# 1986 - 1987 Corvette: Service Bulletin: Convertible Top Number 5 Bow Weatherstrip Loose

**Source:** Chevrolet Dealer Service Bulletin

**Bulletin Number:** 87-148, Number 10

**Date:** May, 1987

NUMBER 5 BOW WEATHERSTRIP

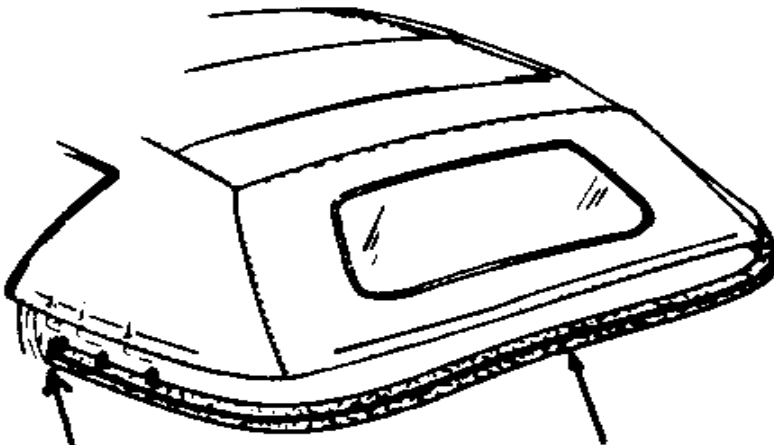
Comments have been reported that on some Corvette convertibles, the number 5 bow weatherstrip pulls loose from the bow at the front ends. Effective with start of 1987 production, the source used an adhesive which eliminated this problem on 1987 vehicles.

FRONT ENDS OF WEATHERSTRIP  
PULL LOOSE AND FOLD BACK.  
MAKE SURE ADHESIVE IS APPLIED  
ALL THE WAY TO THE FRONT END OF WEATHERSTRIP.

Field repairs can be accomplished by gluing the weatherstrip ends down with 3M weatherstrip adhesive, P/N 08011, or P/N 12345096-7 weatherstrip adhesive. (See illustration). Before applying adhesive wipe the weatherstrip with alcohol or all purpose adhesive cleaner to remove any mold release compound. Care should be taken to make sure the adhesive is applied all the way to the extreme forward ends of the weatherstrip. Also, be sure the plastic nails are installed properly. If the weatherstrip is damaged, it will have to be replaced.
